City Council October 1, 2019 Meeting

Marketplace Final Development Plan - Parcel B (Office and Garage)

Appellant: Wareham Development

Figure 1: PDP 2008 and FDP 2019 FDP Massing Studies from West and South-East

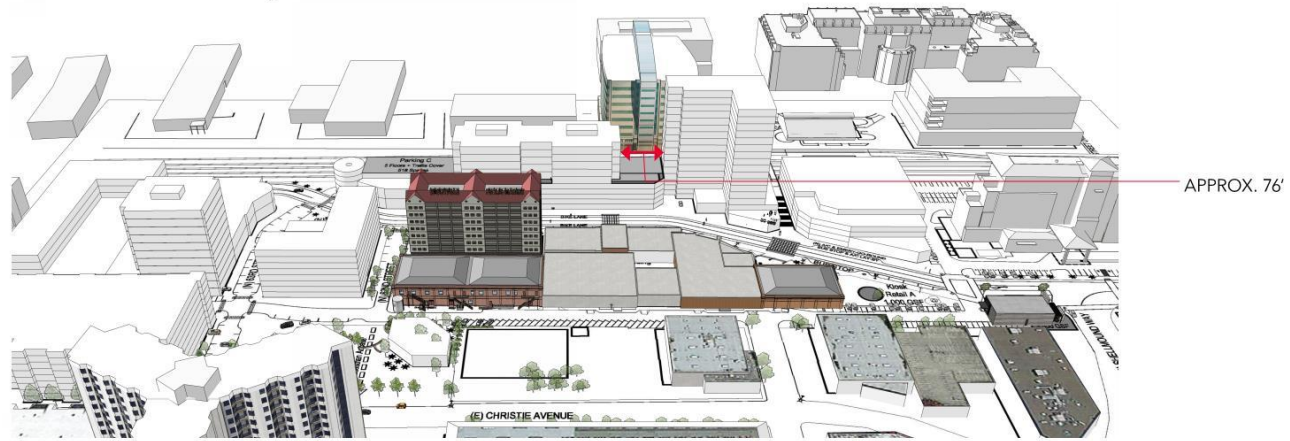
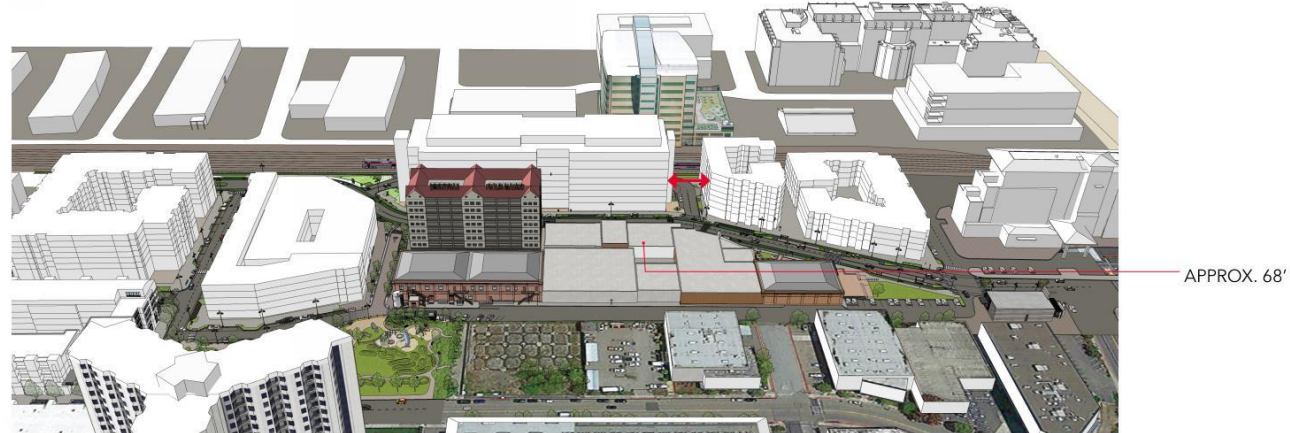
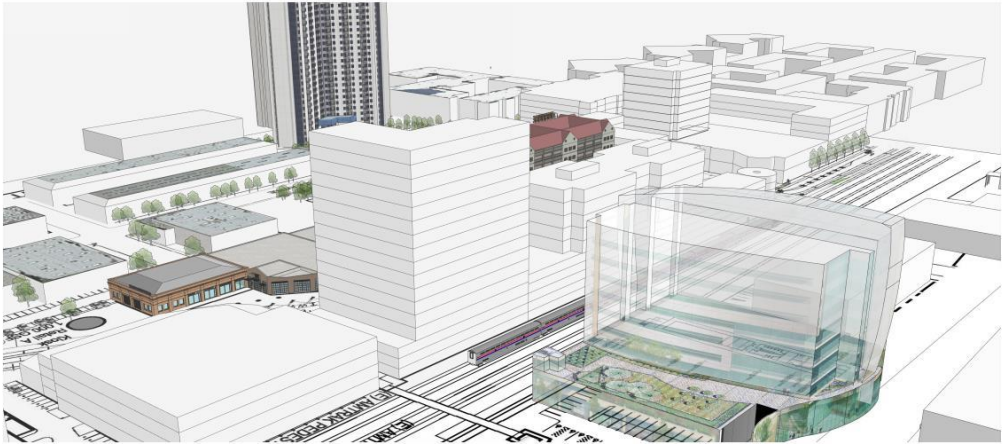
(1) Requirement AES1 calls for the final designs to create a “vital streetscape that enhances the pedestrian experience, avoid blank walls or box-like forms.” The original 2008 approval indeed included large buildings along the railroad tracks. However, in the original approval they have varying and modulated heights and façade, with several important openings and livable gaps between different building gaps.

PUD/PDP	FDP
Parcel A	175 feet	86 feet – northern end 50 feet – southern end
Parcel B	120 feet	112 feet

Figure 1: PDP 2008 and FDP 2019 FDP Massing Studies from West and South-East

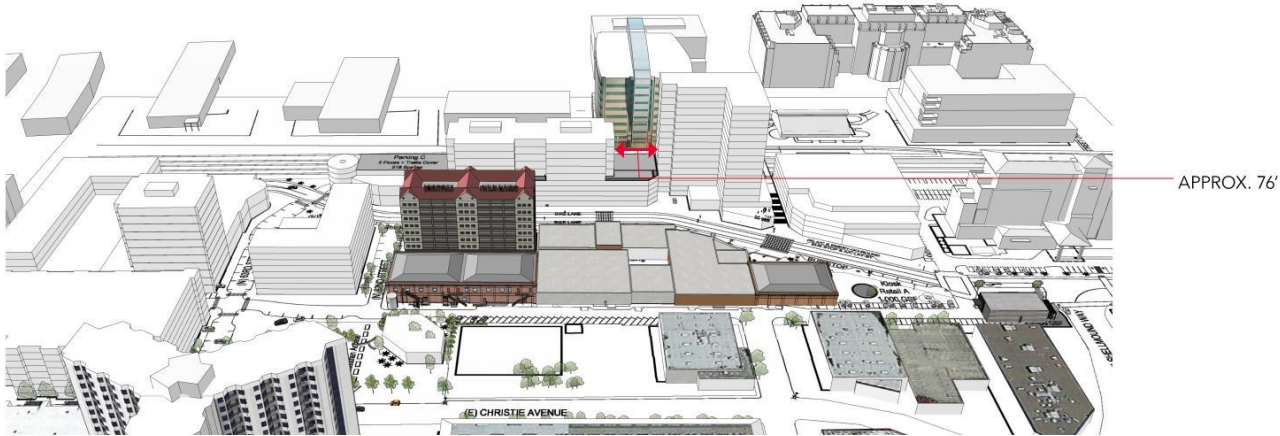
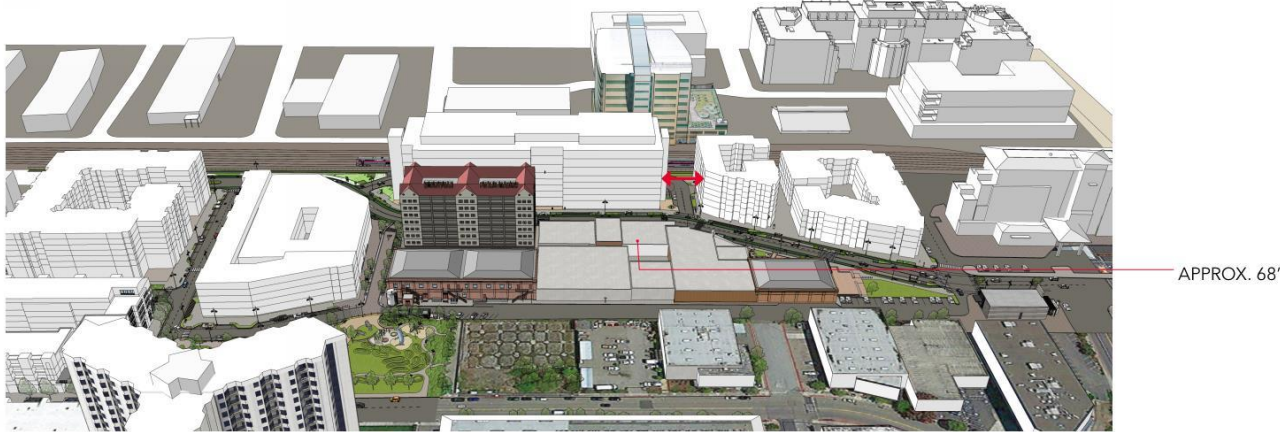
(3) WIND 1 also specifically says that any Final Design should “avoid narrow gaps between the buildings where winds could be accelerated.” The current design does the exactly the opposite. The prior approved design for Parcel B has roughly 170-foot gap between it and the approved Parcel A.

- The Commission needs to make a finding that a FDP is consistent with the PUD/PDP; and not that the proposal is consistent with a previously approved project.
